Network Working Group
Request for Comments: 175
NIC 7074

Comments on "Socket Conventions Reconsidered"

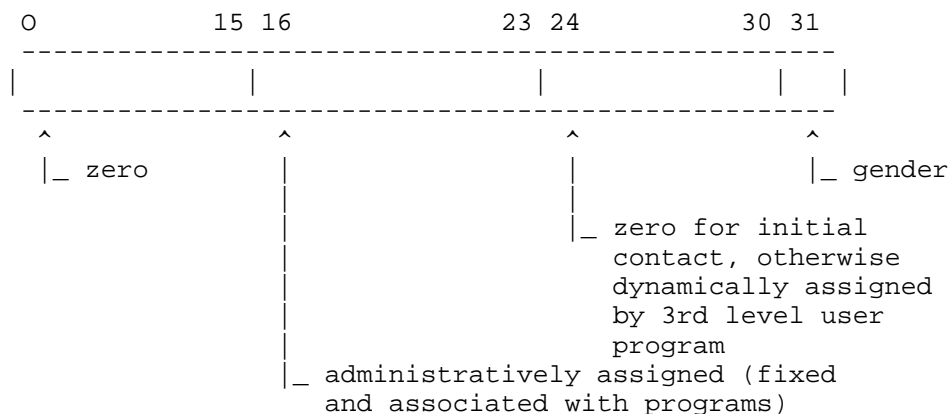
Our current use of socket names is diagrammed below.

(NOTE: This scheme corresponds exactly with both UCSB and UCLA/CCN conventions).
